# CITY PLANNING COMMISSION

APPLICATION: Special Permit for Drive Thru

LOCATION: 2693 Florin Road

PROPOSAL: The applicant is requesting the necessary entitlement to install a drive thru window in an existing fast food restaurant on .5± acres in the General Commercial (C-2) and General Commercial-Review (C-2-R) zones.

**LANDSCAPE PLAN**

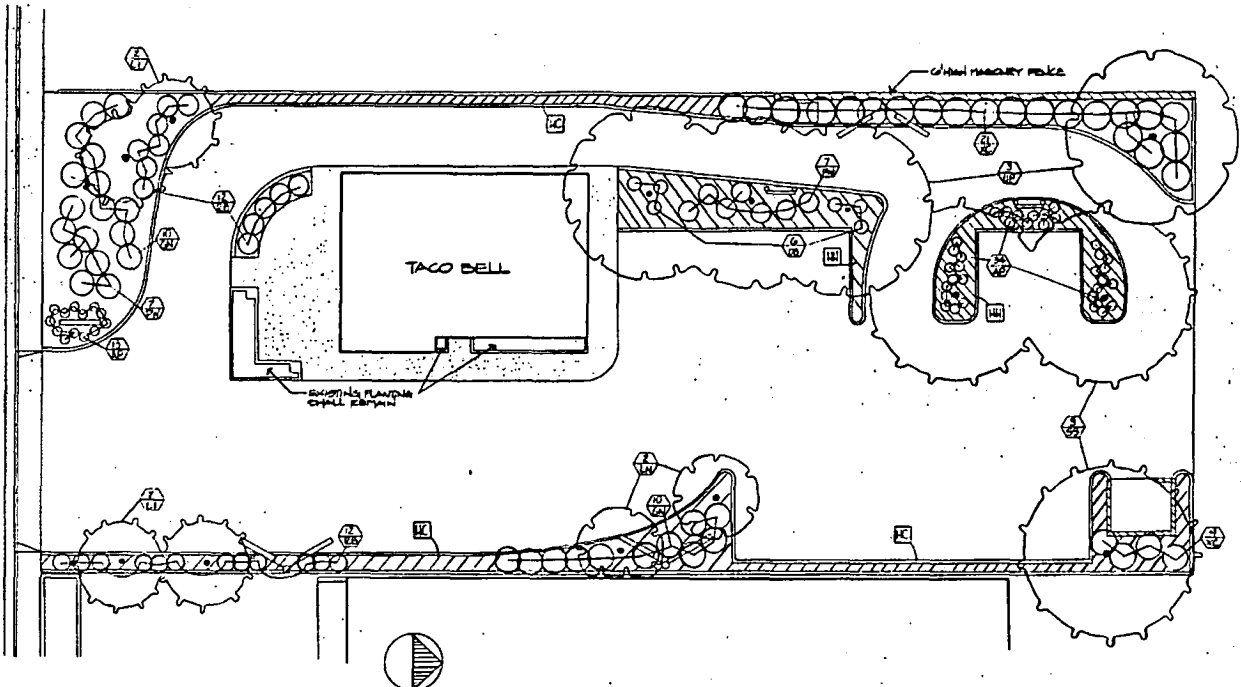
3. The proposed project provides adequate stacking distances. Any addition of traffic generated by the proposed drive-thru should be minor and would not create congestion on Florin Road.
4. A six-foot masonry wall is required adjacent to a residential zone/use. The northerly 74 ft.-6 inches of the westerly property line is adjacent to such a zone. Submitted plans indicate a new six-foot high masonry wall will be built in conformance with requirements.
5. Any additional signage other than a single menu board for the drive-thru and directional signs should conform to the City Sign Ordinance.
6. The proposed landscape/shading/irrigation plans should be revised to accurately indicate the amount of paving/shading/landscape provided. The submitted plan is not accurate in terms of the total square footage of paved area and shading area.

A revised planting/landscaping/irrigation plan shall be submitted for review and approval prior to issuance of building permit.
